RECORD OF ACTION

Planning & Zoning Commission

Tuesday, December 8, 2021 | 6:30 pm

1. Mount Carmel Hospital at 3865 Bright Road 21-158CP

PROPOSED SITE PLAN

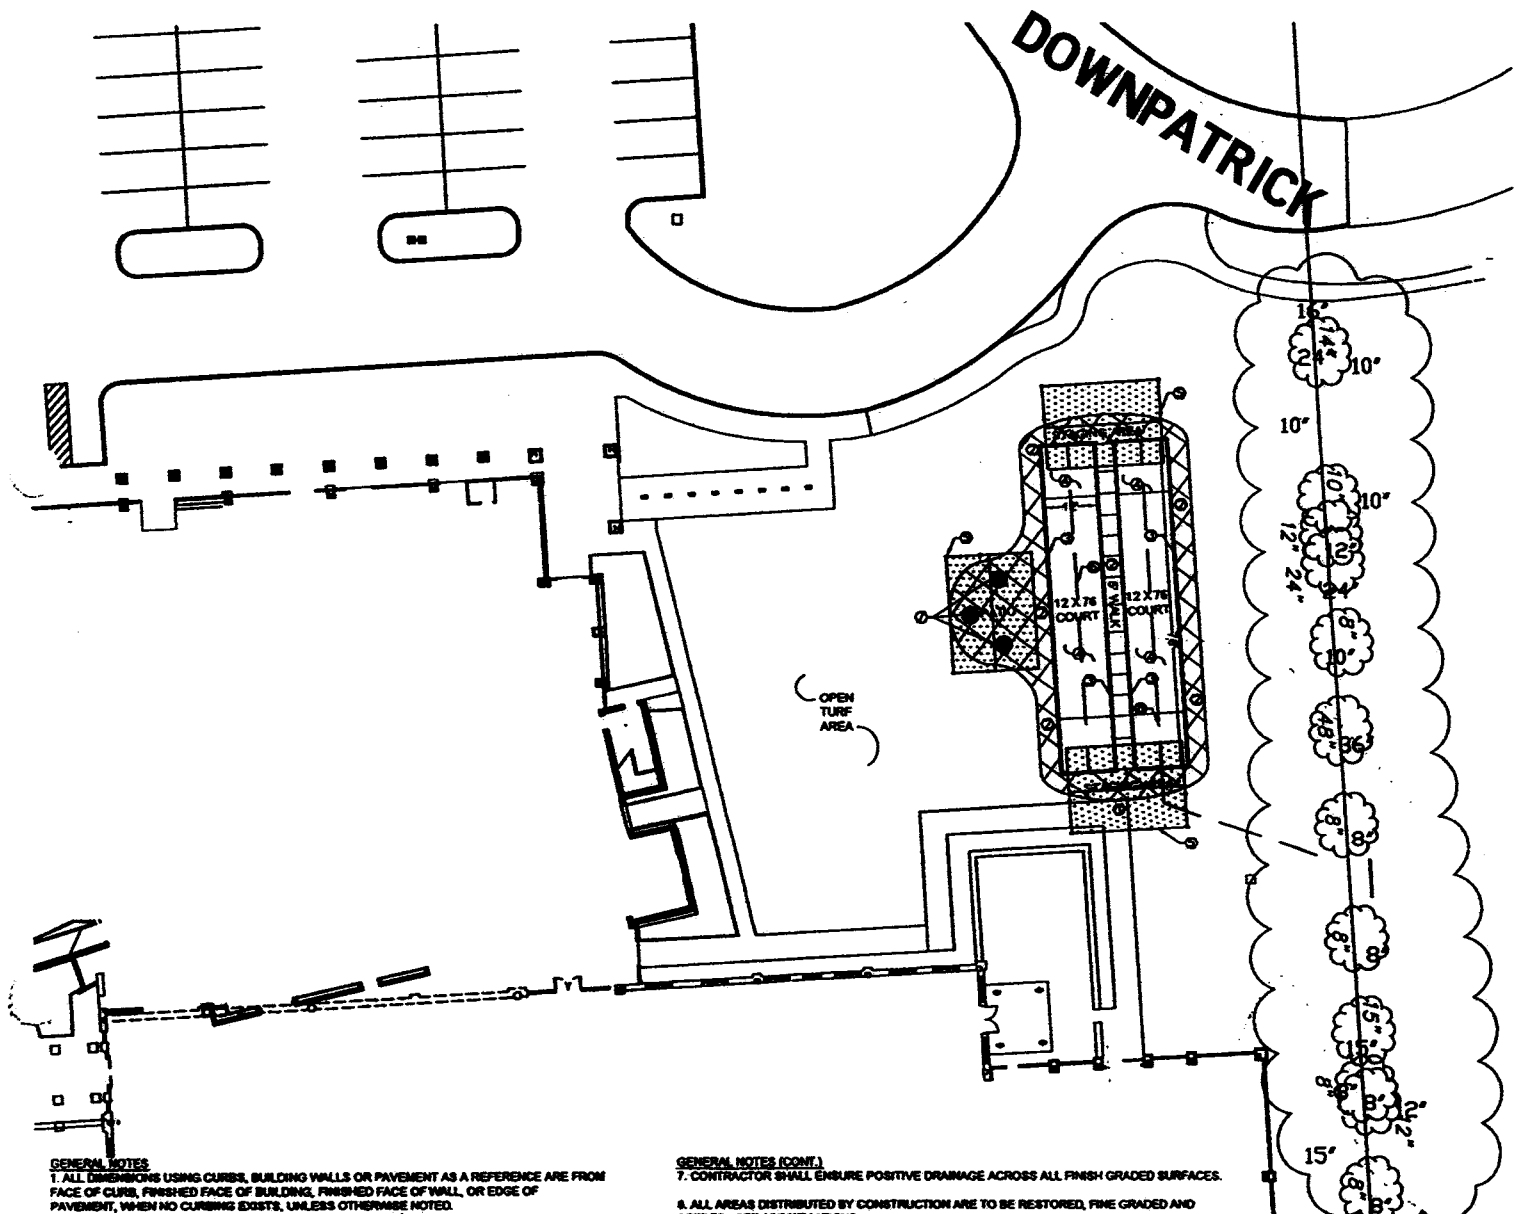
- 1) That the connection of the existing walkway and the proposed walkway around the courts be reconfigured for better accessibility, subject to staff approval.
